***Interactive comment on* “Dynamics of wormhole formation in fractured karst aquifers” by Wolfgang Dreybrodt and Franci Gabrovšek**

P. Szymczak (Referee)

Received and published: 1 August 2018

Fig. 1. Dissolution of a single fracture of Dreybrodt and Gabrovsek network. Colors indicate deep erosion (red), intermediate erosion (yellow and green), low erosion (blue), no erosion (black).

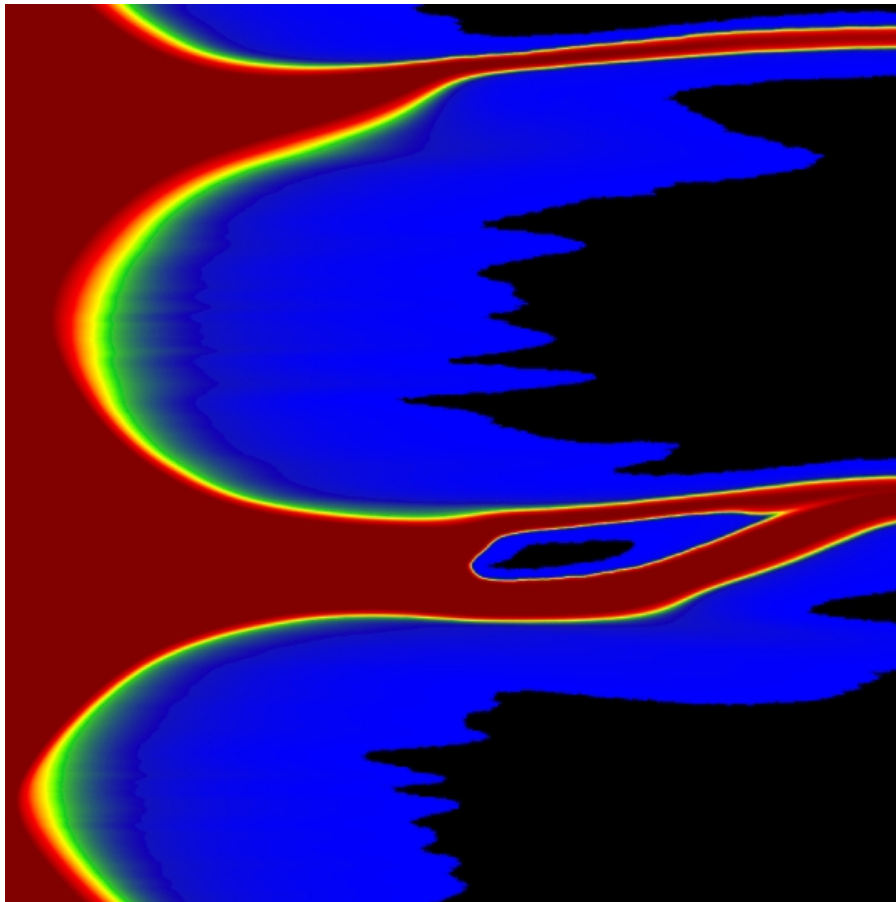
2. Applicability of the model to the real systems: the authors claim that individual fractures in the model will dissolve uniformly – I have serious doubts as to the validity of this statement. To test it, I have carried out the simulations of a single fracture element of Dreybrodt & Gabrovšek network as well as four elements of this network joined in series. I have taken the Péclet and Damköhler numbers as quoted in the m/s (btw, the estimate of the penetration length on p. 25 of the manuscript seems to be erroneous – $l_p = va/2K = a/2Da$ gives $l_p = 31.25\text{cm}$ for $a = 0.02\text{cm}$ and $Da = 0.00032$ and not 16cm as reported in the paper). The results are presented in the attached Figures

They clearly show that even a single element of the network dissolves nonuni-

formly, contrary to what is stated on p. 25 of the m/s (where it is suggested that the dissolution in the first five elements of the network should be uniform). Nonuniform dissolution of individual elements of the network means also that one cannot impose constant pressure boundary conditions across the fracture-fracture intersections (white lines in Fig. 2), as the pressure will be highly nonuniform there, with the maximum along the developing wormhole. As a result, the pattern which would develop in such a system will consist of circular conduits and not uniformly opening fractures. The flow focusing will not change that much in this picture – our simulations indicate that the widths of the channel scale sublinearly (as $q^{1/3}$) with the flow rate, thus the conduit will still remain localized (only getting thicker with time) and the pressure will not be uniform across the fracture width. In general, I find the assumption of the uniform pressure across the lines joining fractures really dubious – it is true that such an assumption is often made in the case of network models where each link is a capillary/conduit and the intersection is supposed to be small in size compared to the capillary length; here however the width of the intersection (2m) is the same as the length of individual fractures. Imposing a uniform pressure along each such intersections (white lines in Fig. 2) changes the dynamics of the system in a dramatic way.
